**Application for Minor Amendments
to the Building B5 Reserved Matters
Approval 2014/6968/P**

King's Cross Central General Partner Ltd

September 2015

drawing no
EPA KXC 05 114

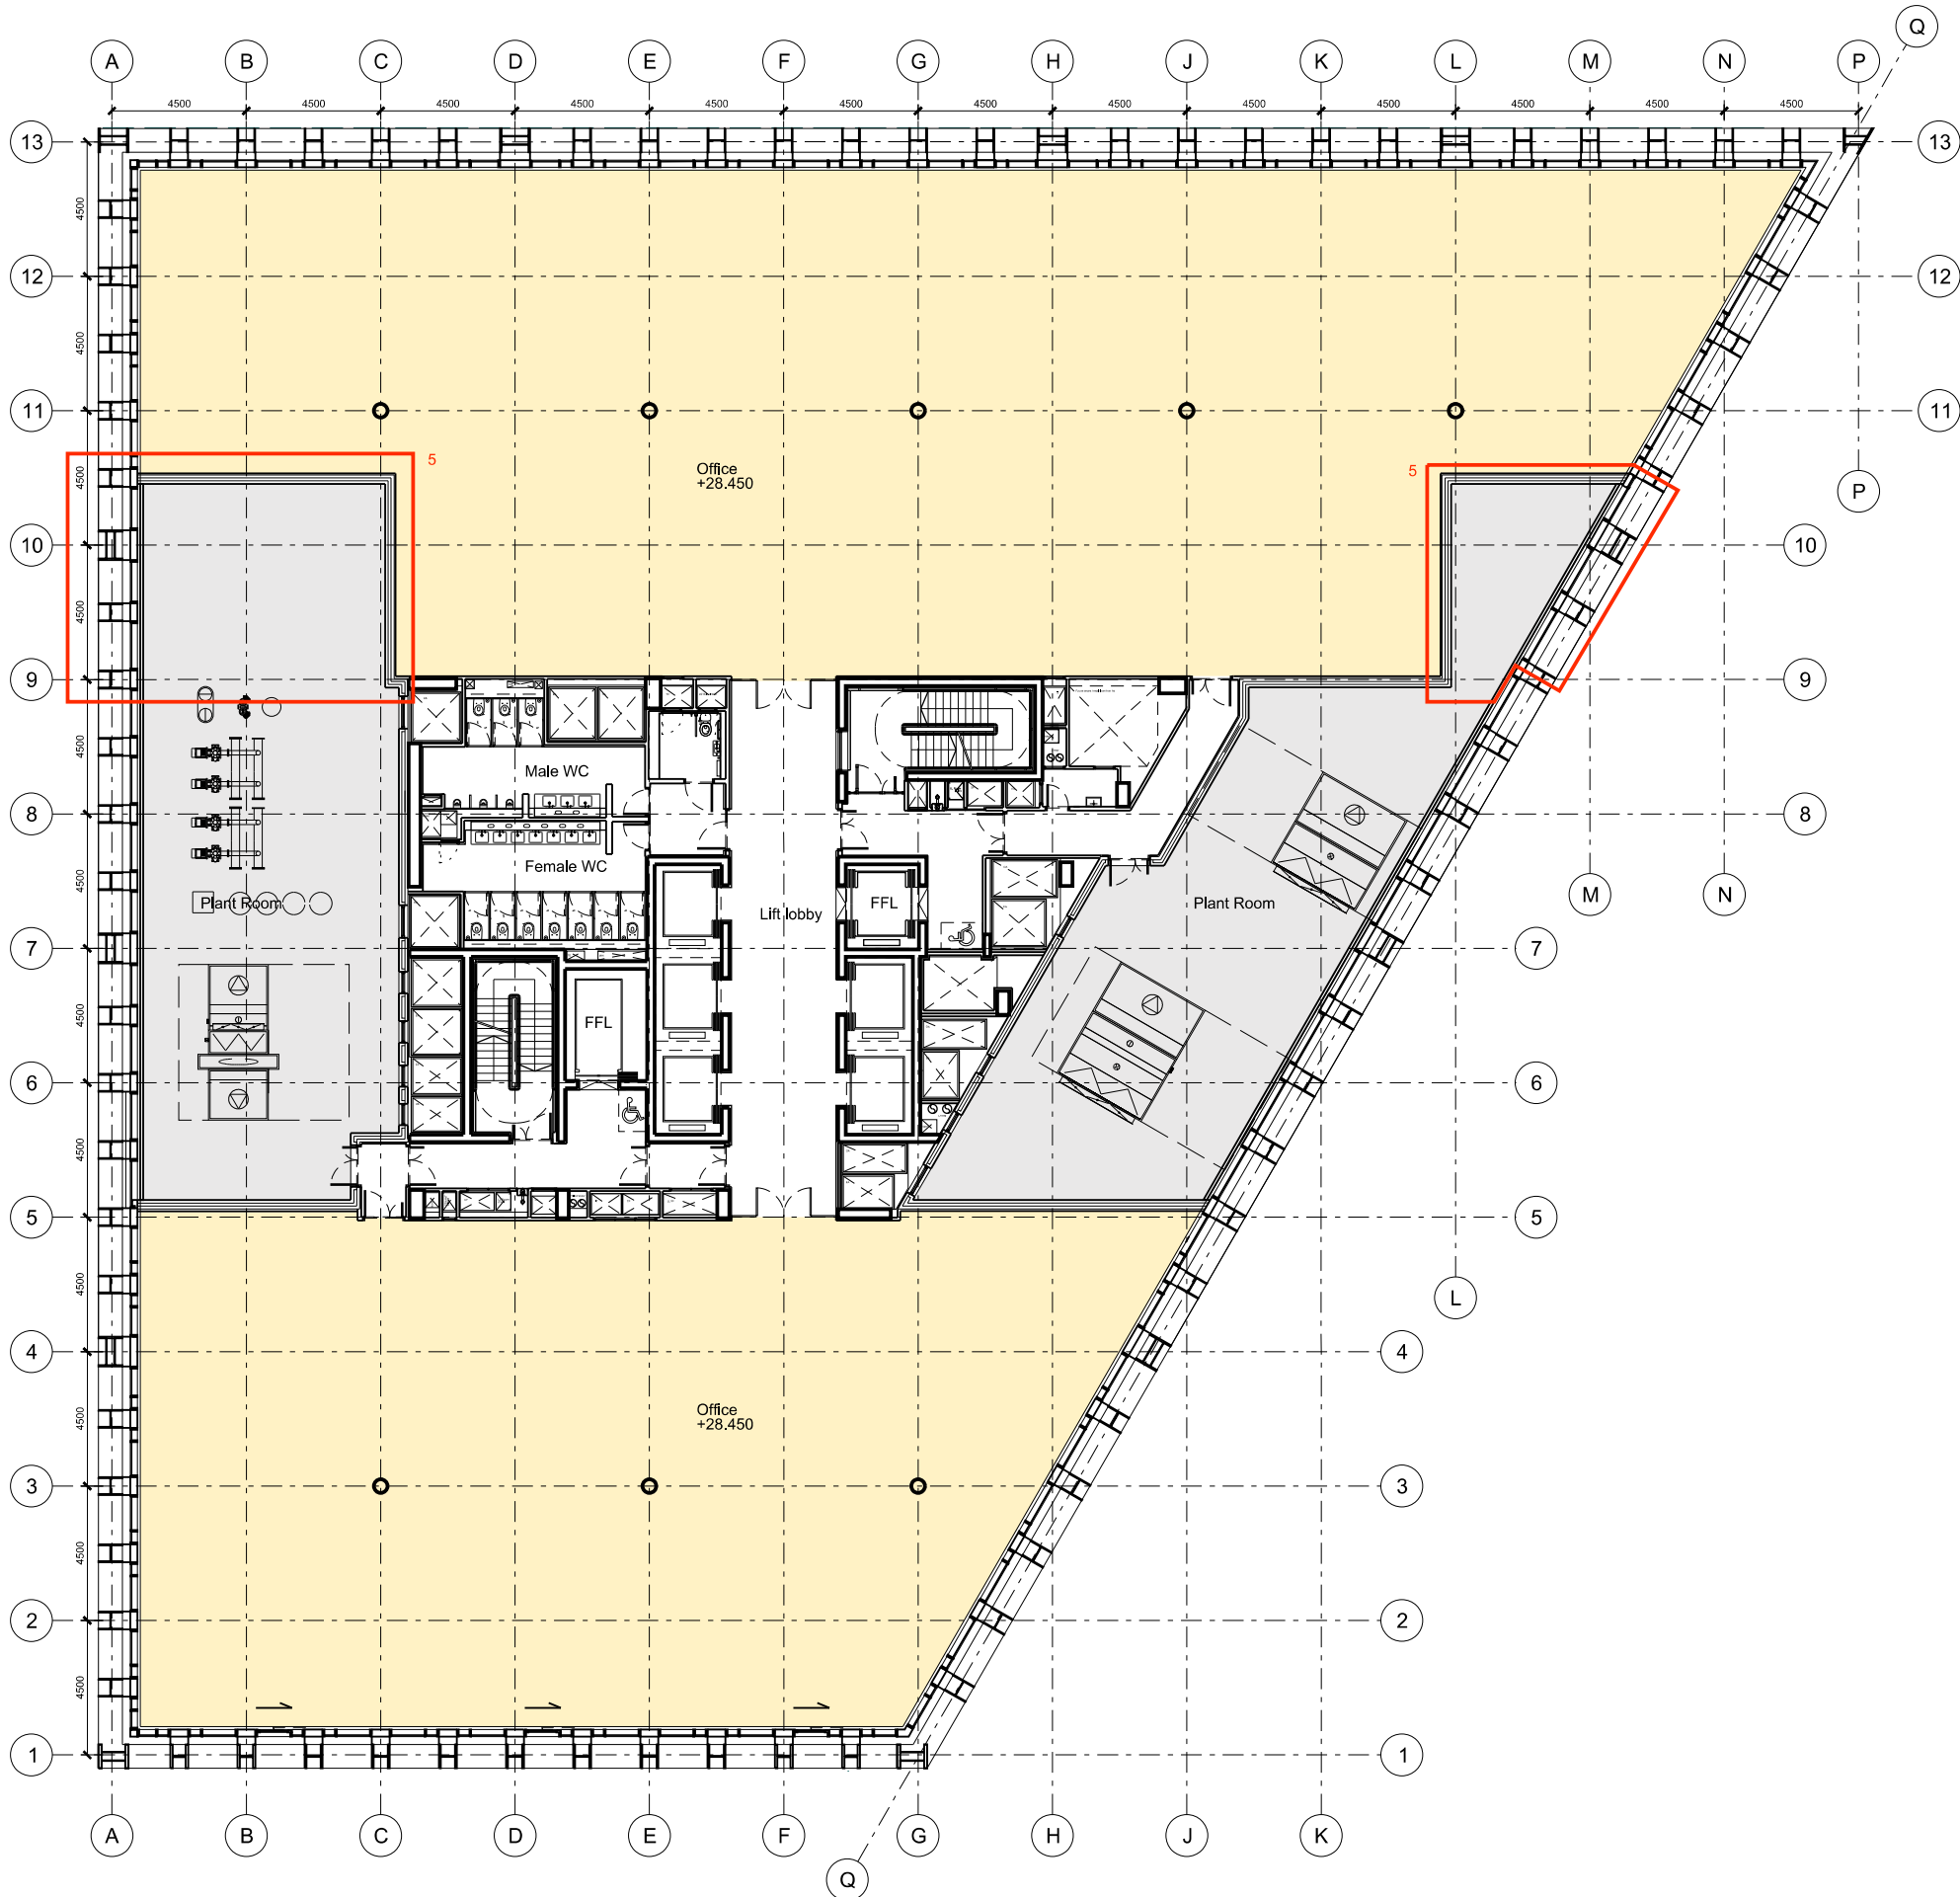
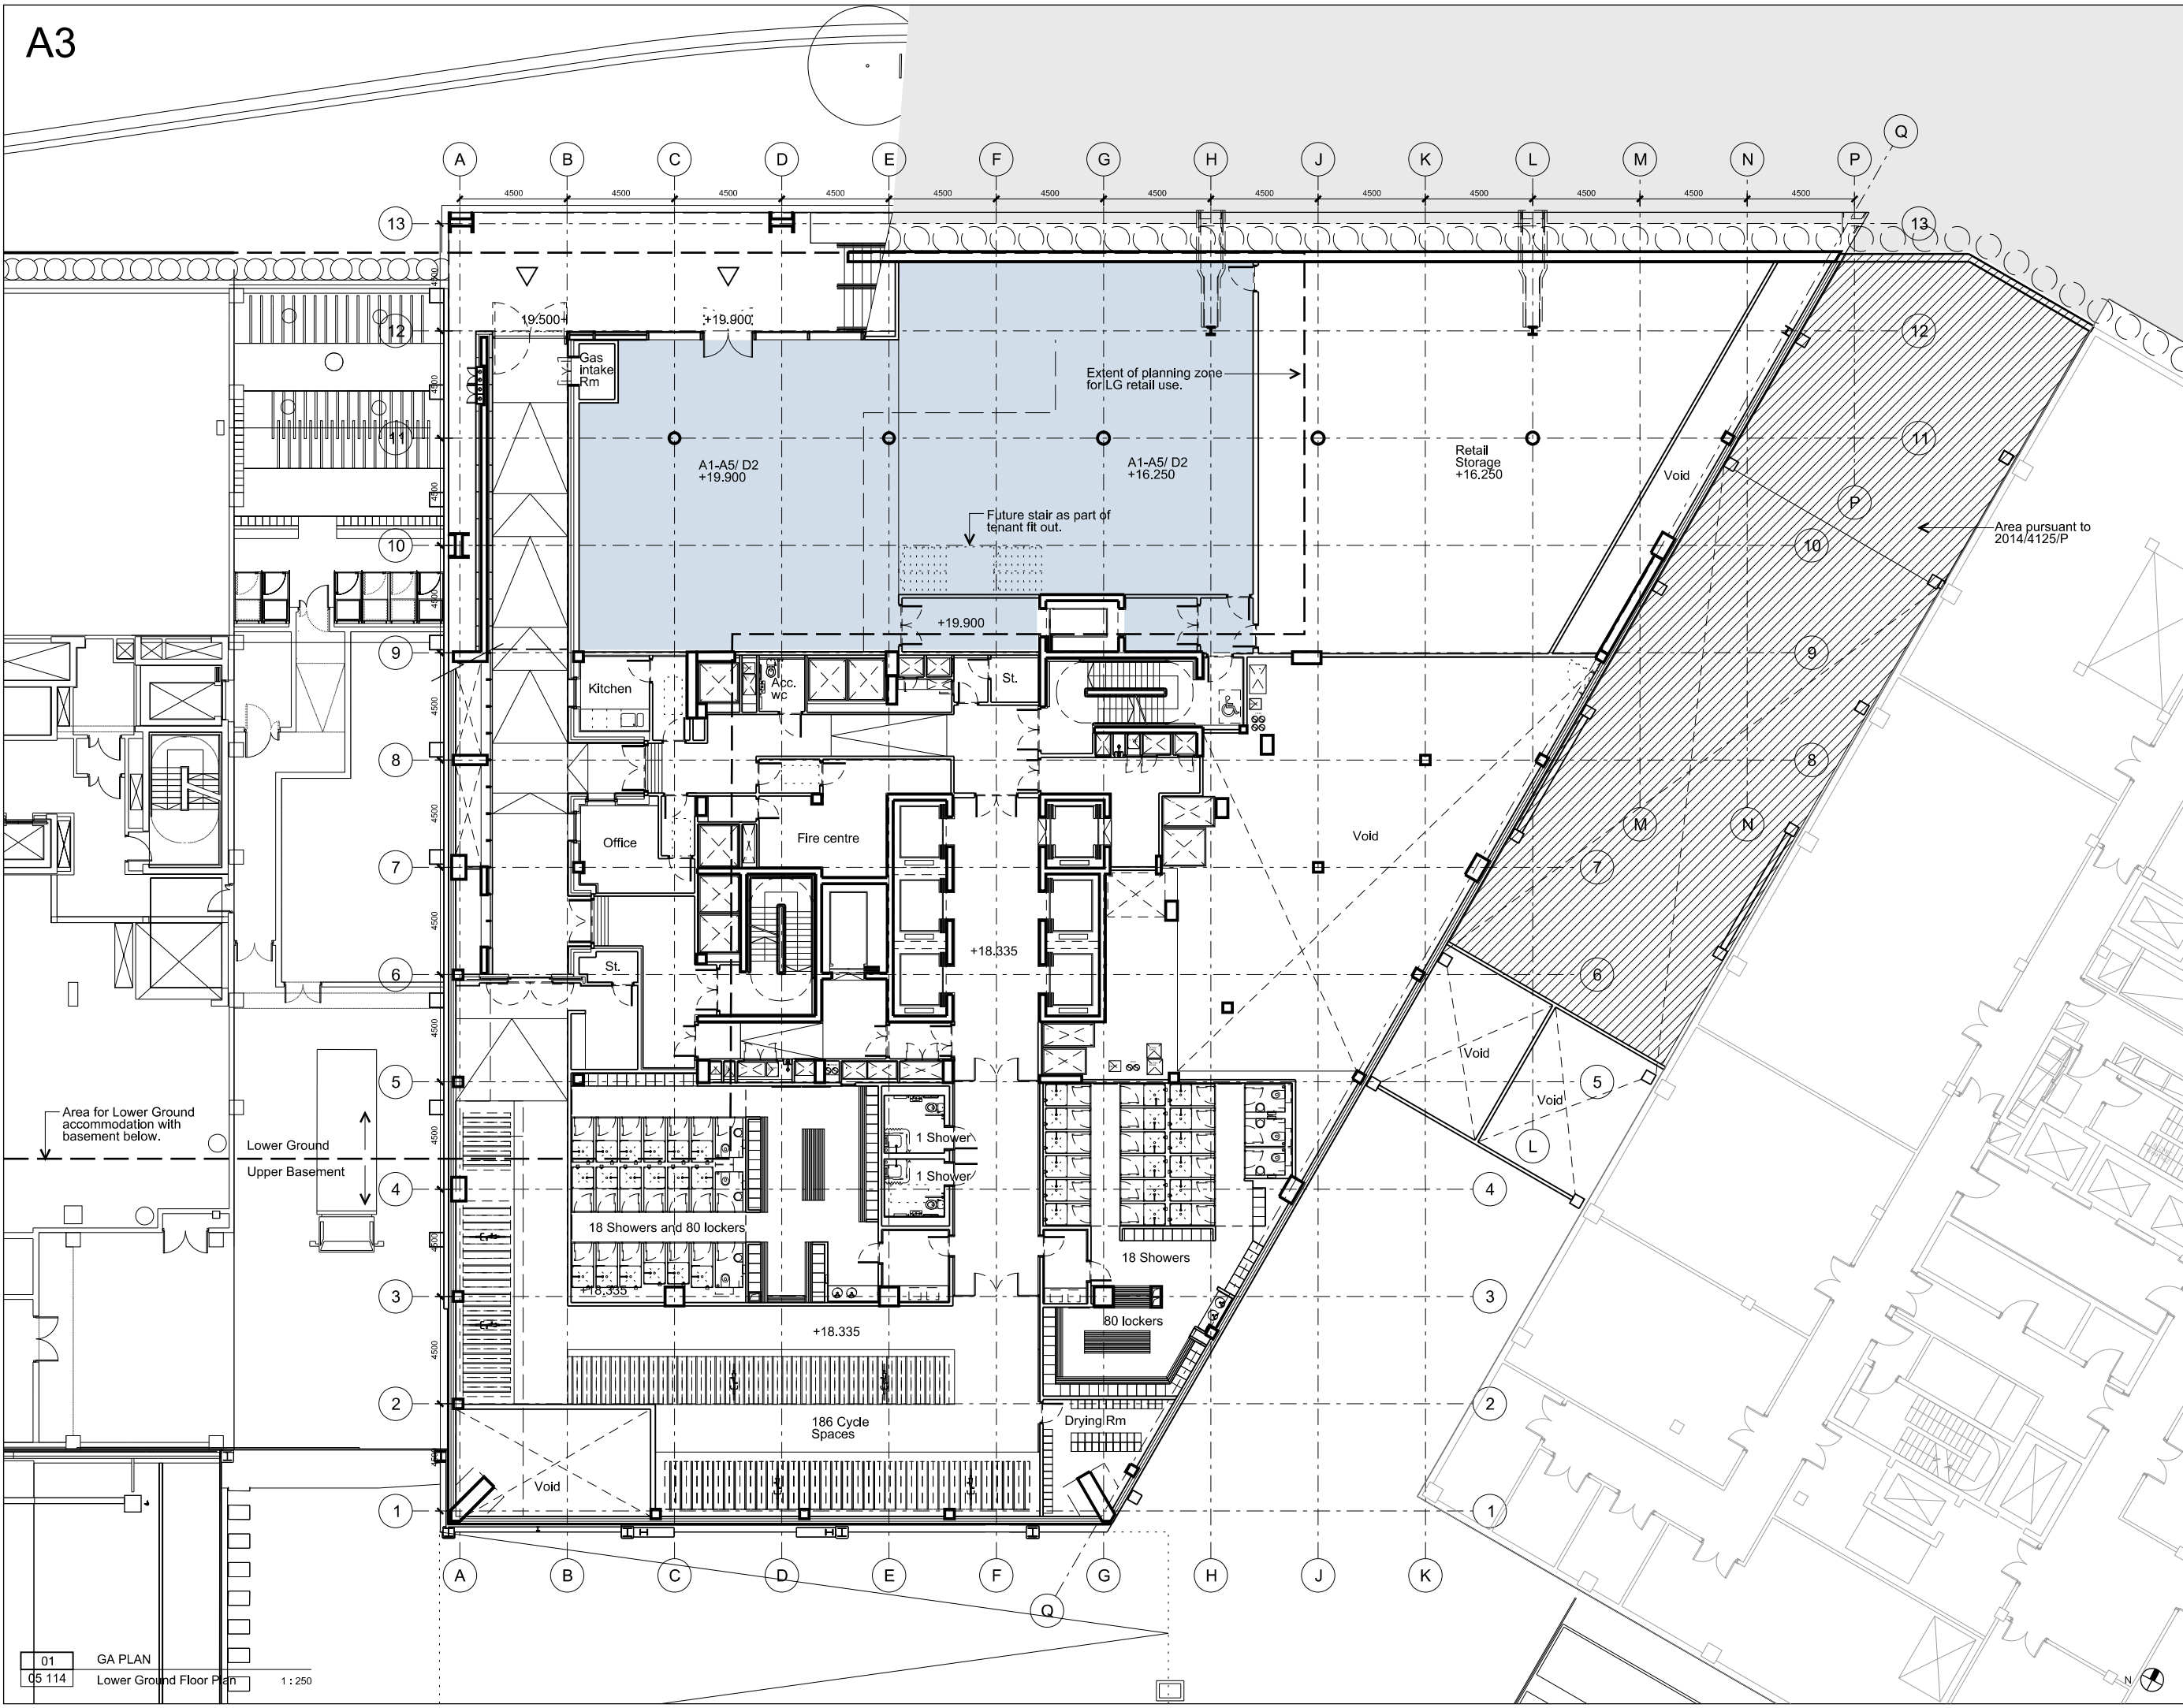
1. Gas Intake Room relocated to top of cycle ramp, louvered doors inserted to ramp side, and mullion and shadow box added to north facade, to conceal the Gas Room. Doors to Cycle Store centred on ramp, following relocation of Gas Room.
2. Fourth Inlet cabinet added.
3. Louvres added to wall of cycle ramp to serve plant room below.
4. Retail area reduced following a shift in the wall between the lower ground retail floor and the upper basement retail storage areas; retail storage remains the same, by creating a void at its eastern extremity.

Rev	Description	Date	By	Chk
P4	Storage area reduced in size.	07.07.15	MM	RD
P3	Retail reduced in area.	10.06.15	MM	RD
P2	Town added.	27.05.15	MM	RD
P1	Gas intake room relocated to top of cycle ramp. Foam inlet cabinet added. Louvers added to cycle ramp.	16.02.15	MM	RD
P0	Planning Submission.	29.09.14	JT	RD
